**Town of Kittery
Planning Board Meeting
October 26, 2023**

ITEM 3 – 47 Cutts Road – Major Conservation Subdivision Plan – Preliminary Review

**RE: Town of Kittery, Planning Board Services
Cutts Road Major Conservation Subdivision – Preliminary Review
47 Cutts Road, Tax Map 60, Lot 10-3
CMA #591.164**

SITE DETAILS
TWIN OAKS SUBDIVISION
47 CUTTS ROAD, KITTERY, MAINE

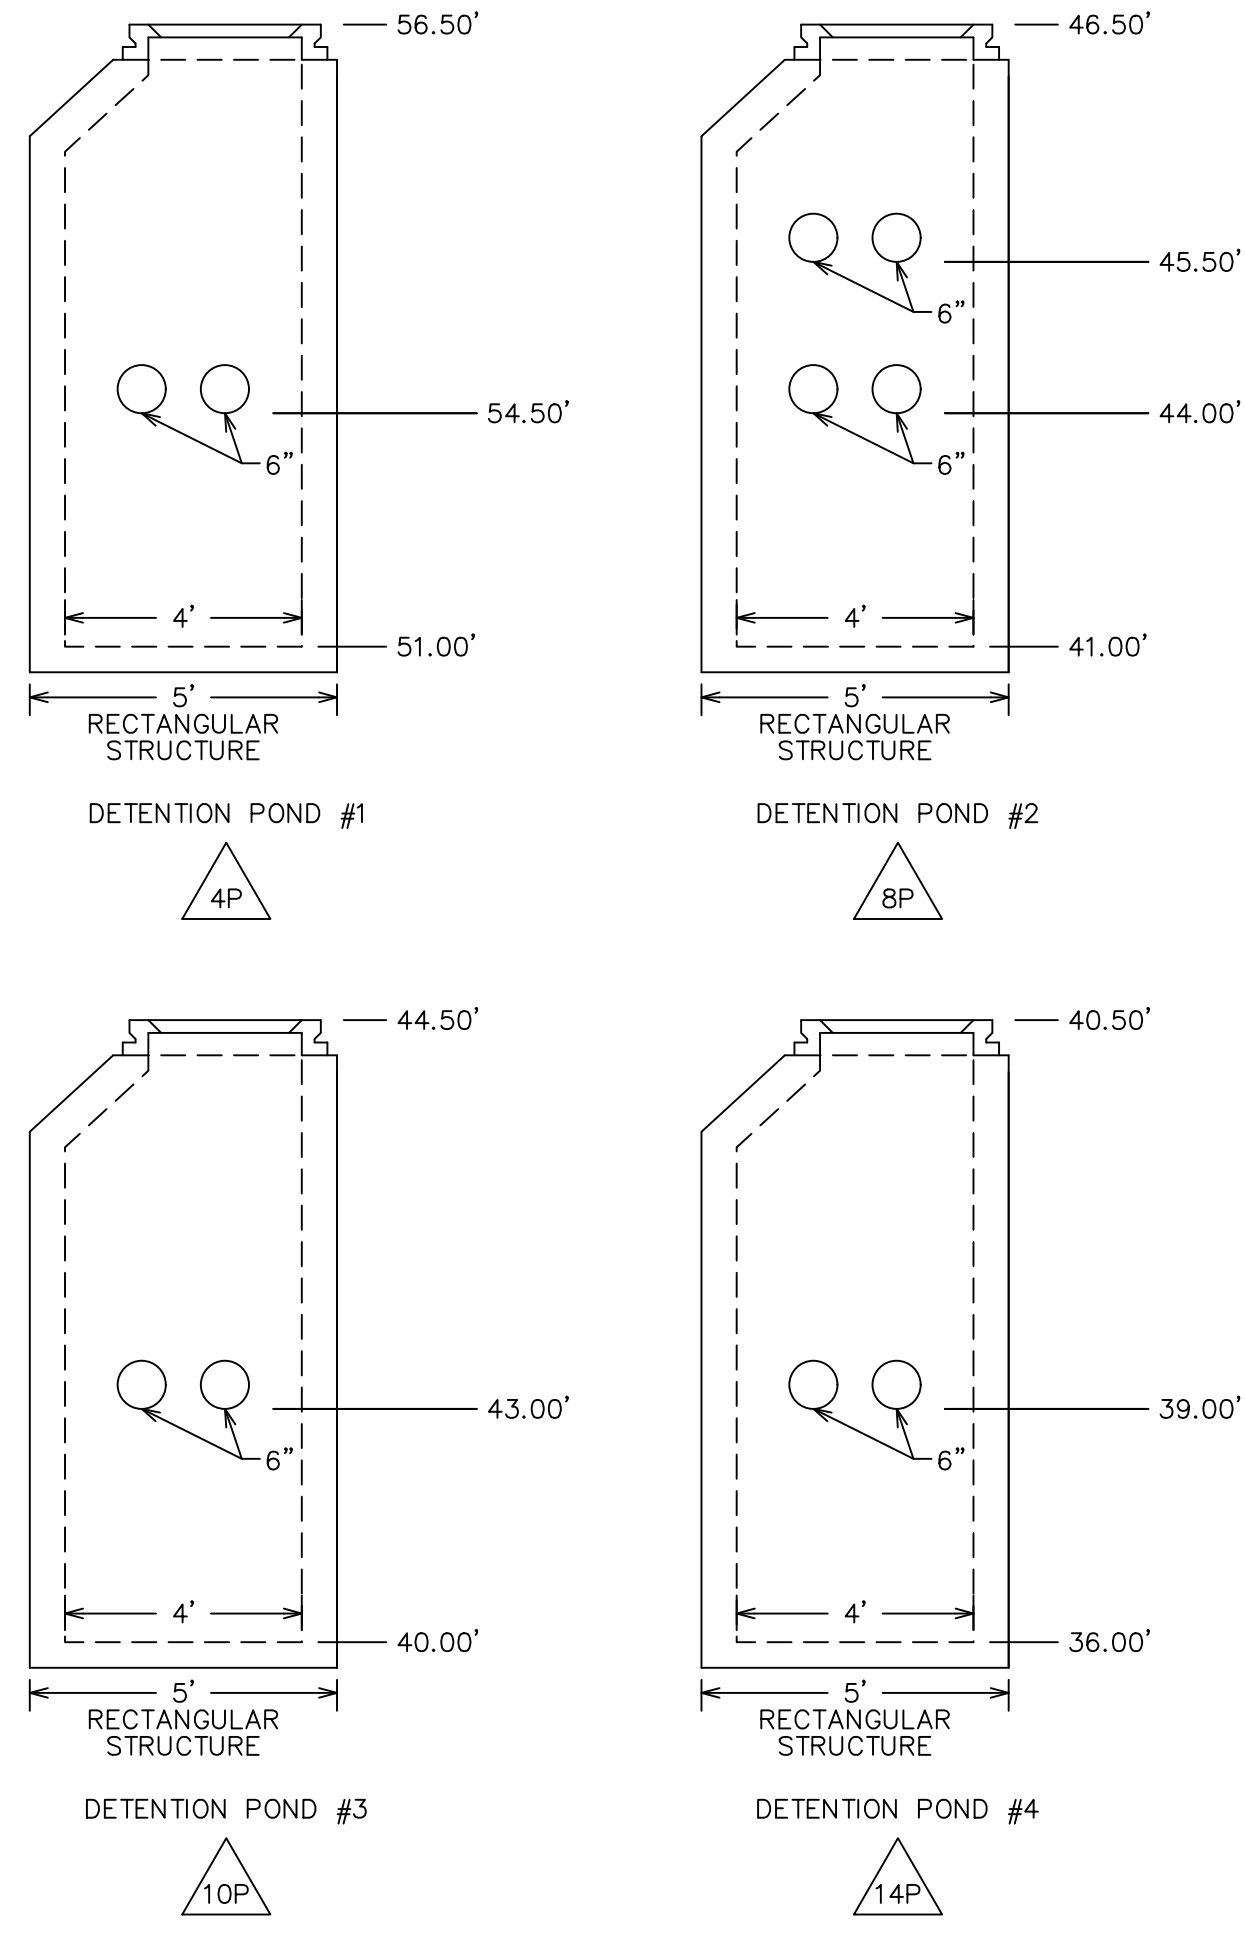
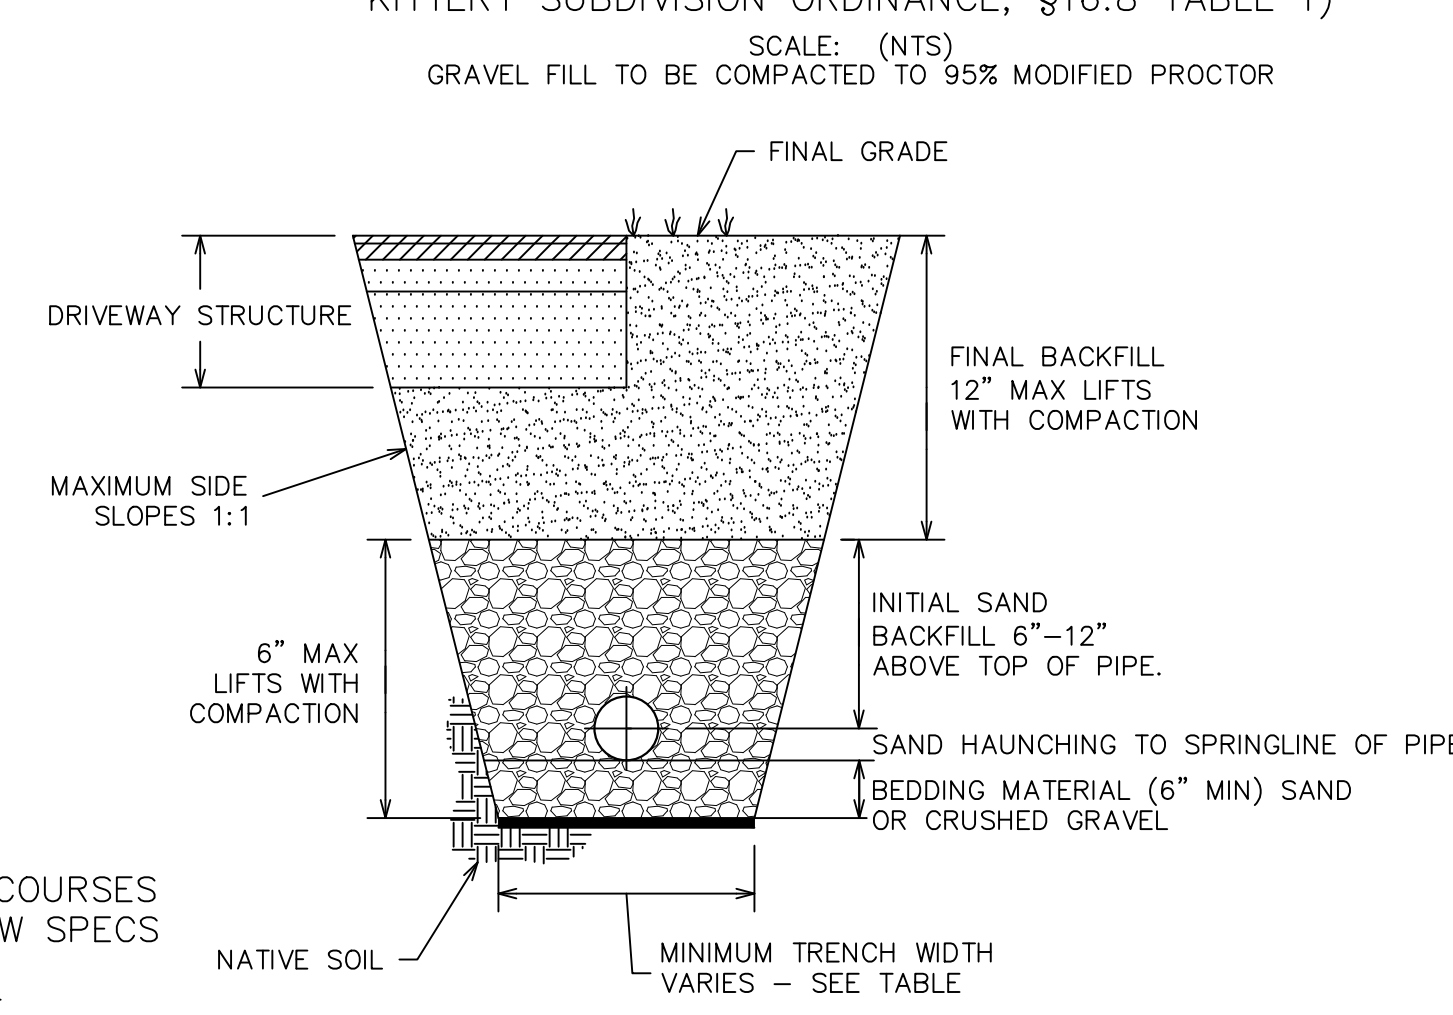
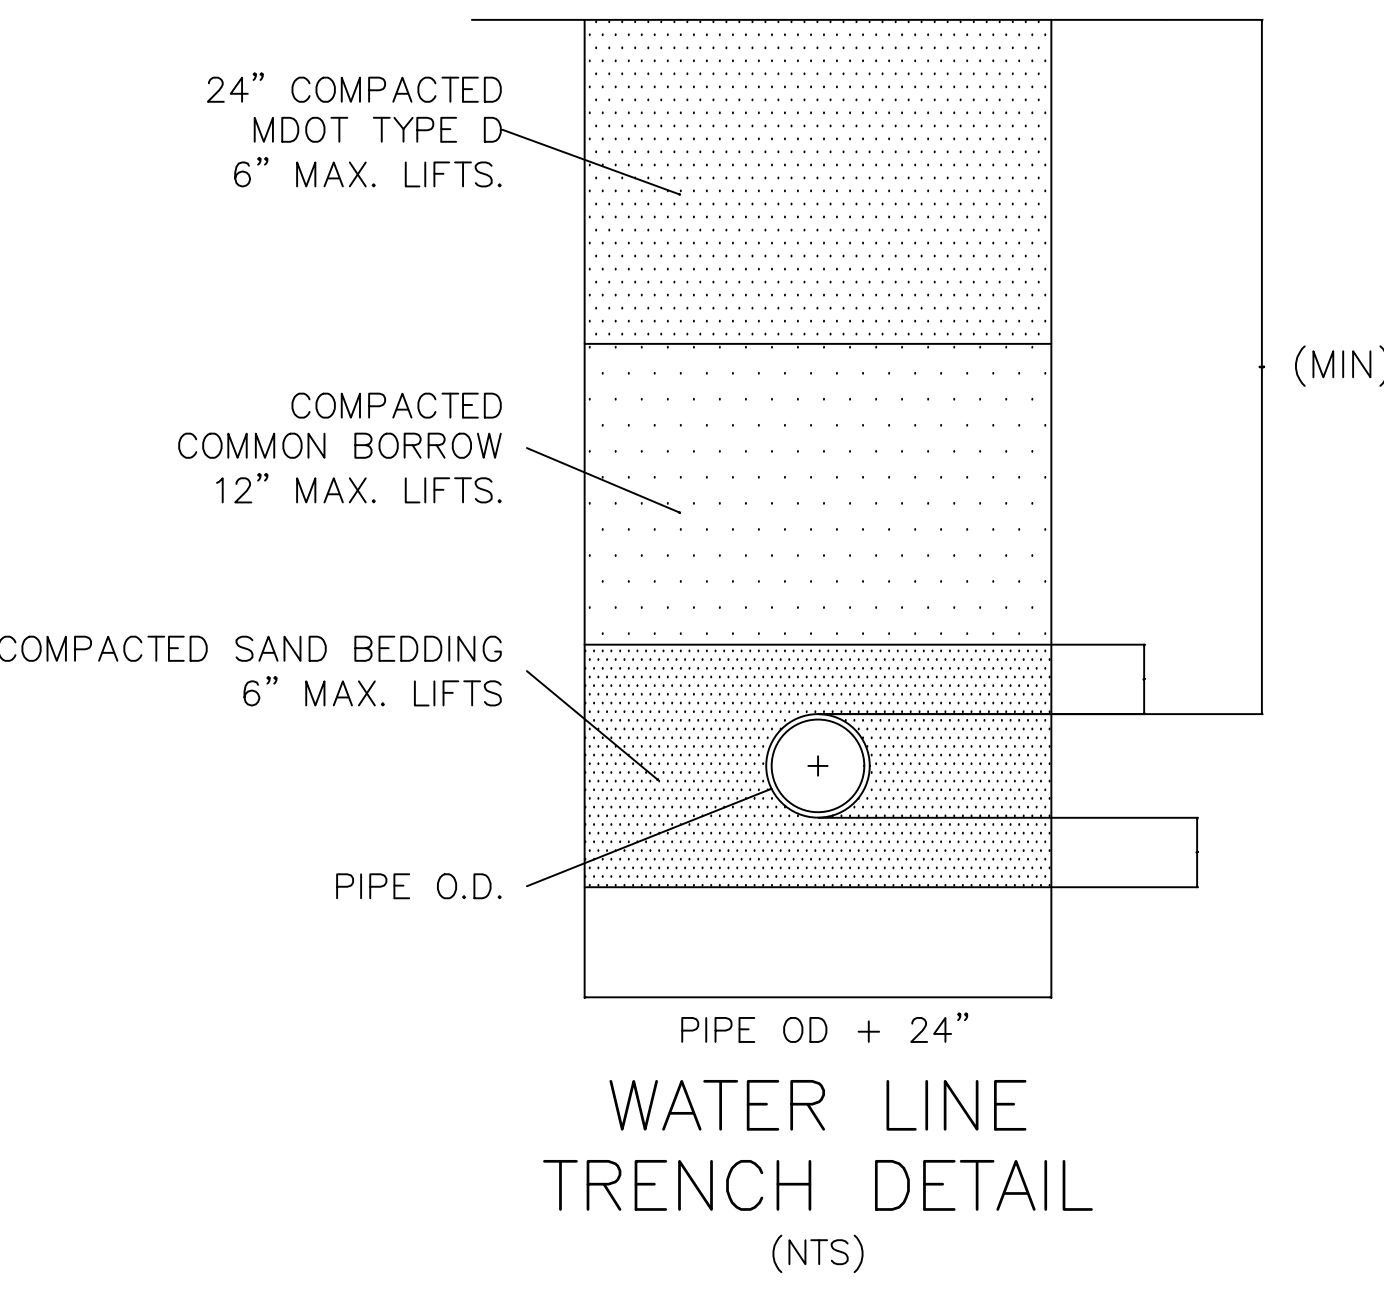
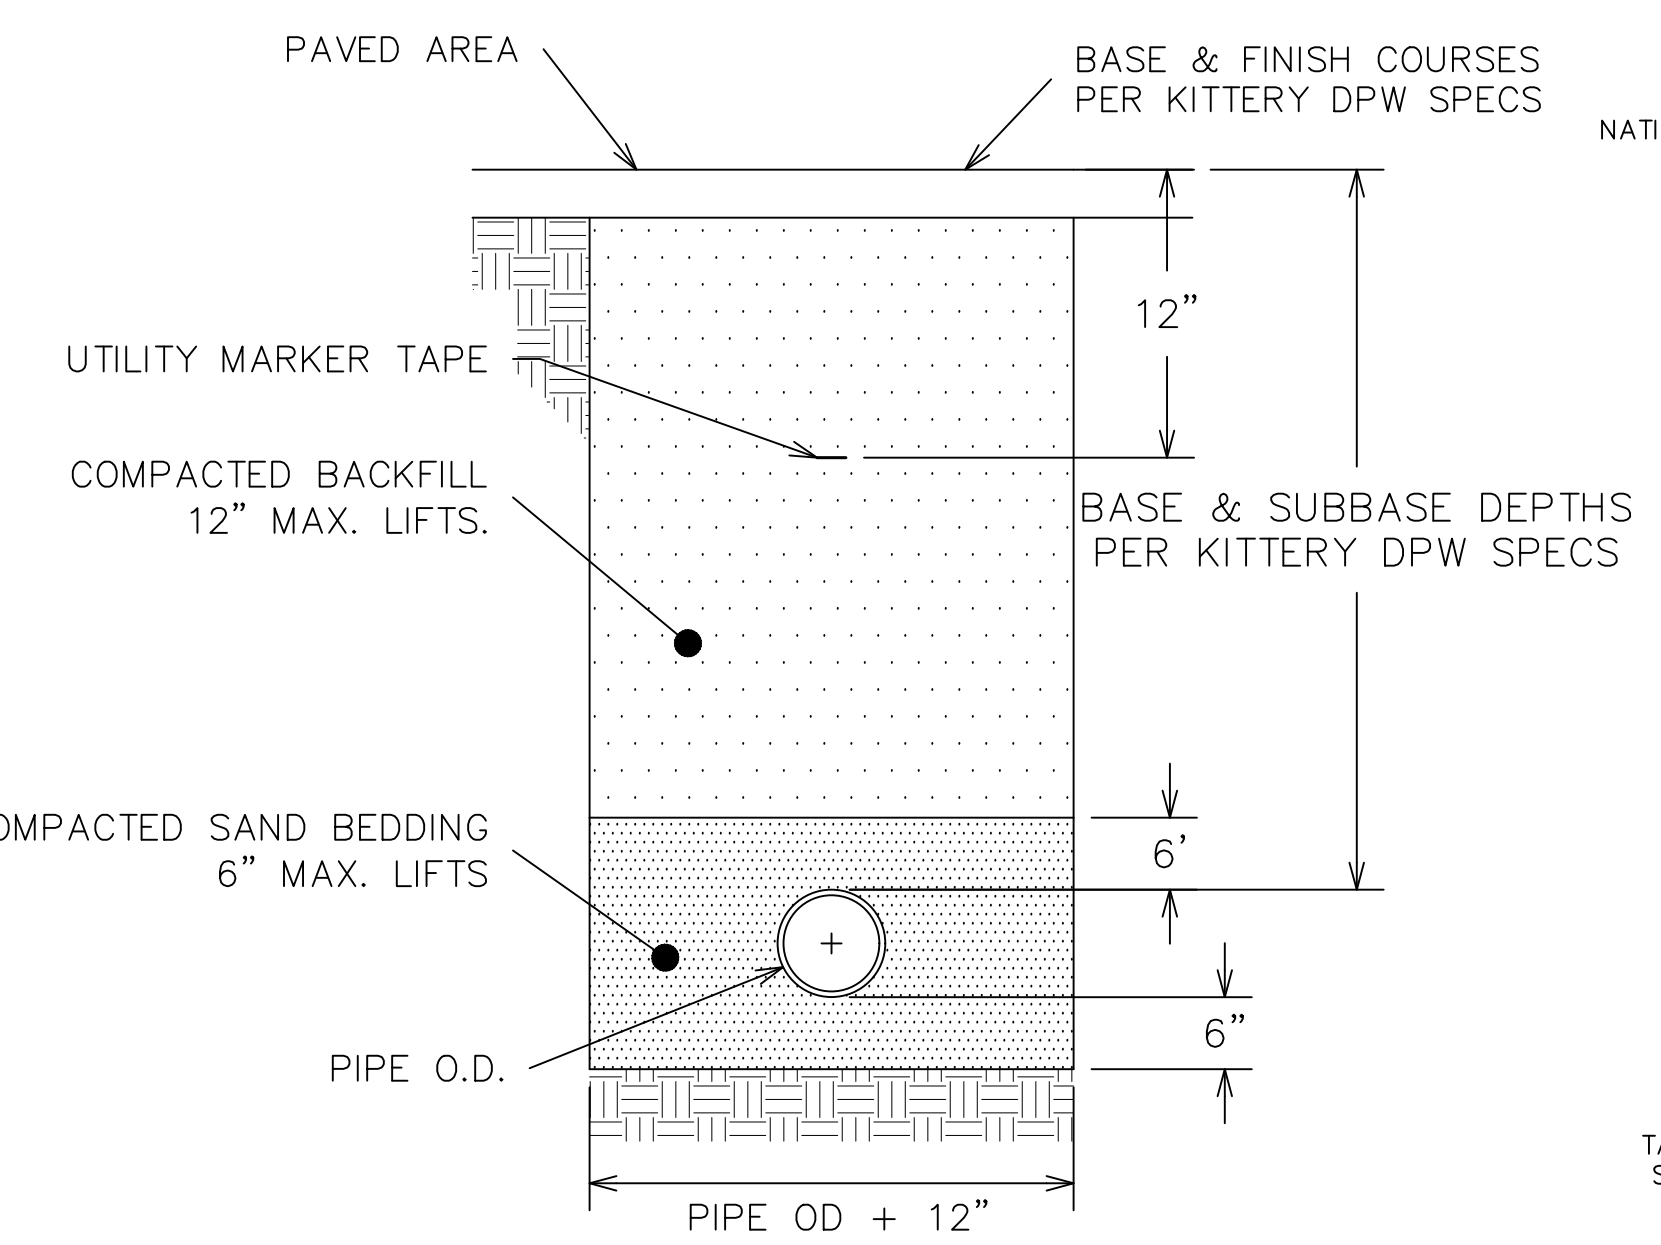
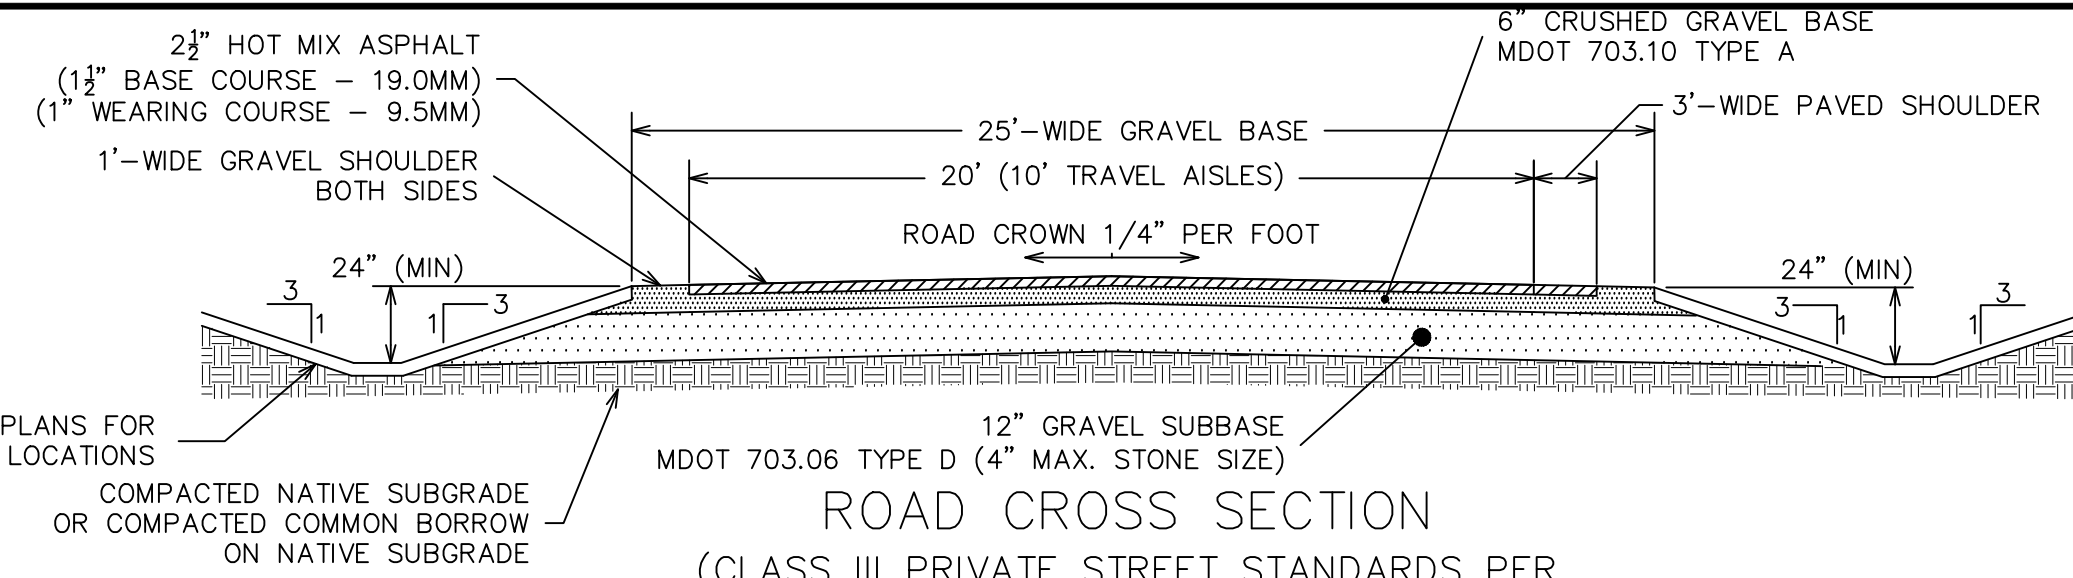
1. The stormwater management ponds should be numbered on the plans to coincide with the drainage report.
2. The peak storm elevations for Detention Pond #4 on Sheet 11 Site Details, provided with the drainage analysis, are incorrect.

1. The Road Cross Section should be updated to reflect the Department of Public Works and Fire Department comments.
2. The Utility Trench Patch Detail should have base and finish course information not "per Kittery DPW specs".
3. The water line detail should include warning tape.
4. There should be a detail for the water main connection in Cutts Road.
5. There should be details for the SSWDS – piping, pumps, etc.
6. There should be detail for water main fittings/bends.
7. There should be a detail for thrust blocks.
8. There should be a hydrant detail.
